Dam Safety Inspection Report

Name: **Shadow Lake**
State ID: **81.02** NID ID: **VT00070**
Hazard Class: **Significant**

Inspection date: 06/28/2023 10:56

Inspection type: Periodic

Upstream wall images

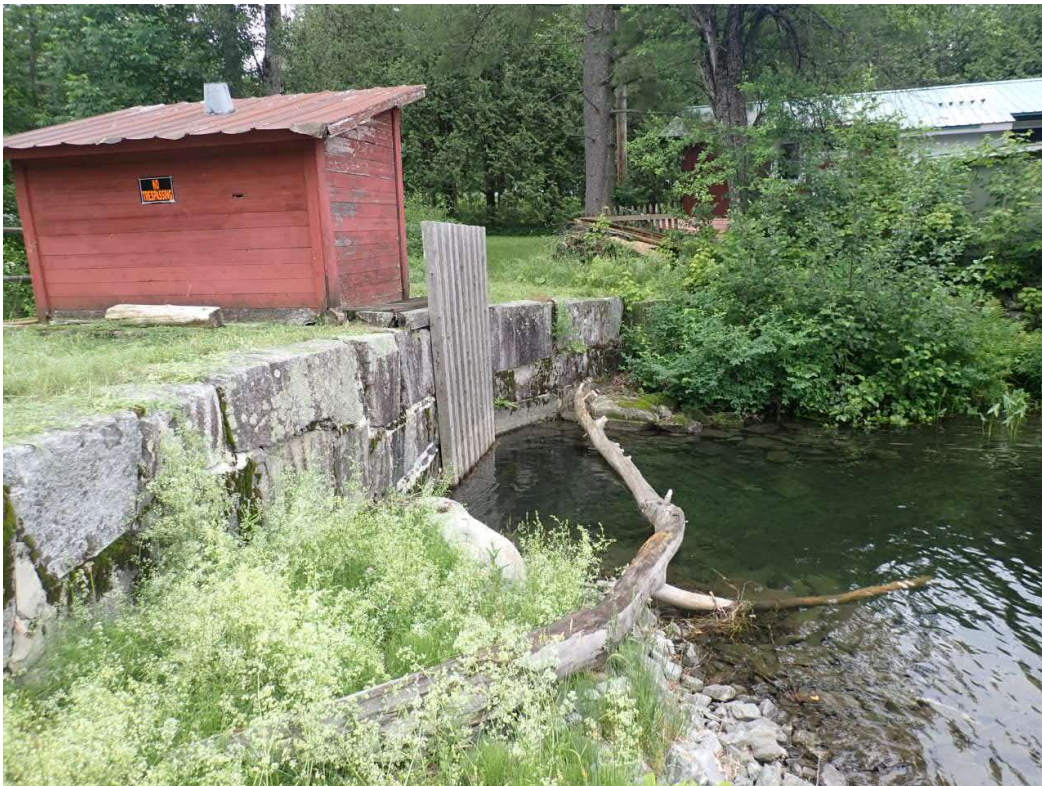
Upstream Wall		
Wall type: Stone Masonry Length: 130 ft		
Wall height (exposed): 5.2 ft above normal pool	Horizontal wall alignment: Good	Vertical wall alignment: Good
Unusual wall movement: <input type="checkbox"/> Yes <input checked="" type="checkbox"/> No		
Additional comments: Stone/riprap has been placed in front of the wall; tall vegetation is growing on the stone/riprap which prevented thorough inspection.		Surface condition: Fair to Good
Joint condition: Good		Abutment contact condition: Good

Upstream wall issues	Action
Vegetation Condition: <input type="checkbox"/> Adequate <input type="checkbox"/> Bare <input type="checkbox"/> Improper <input type="checkbox"/> Sparse	<input type="checkbox"/> None <input type="checkbox"/> Monitor <input checked="" type="checkbox"/> Too tall <input checked="" type="checkbox"/> Maintenance <input type="checkbox"/> Too short <input type="checkbox"/> Engineer
Comments: none
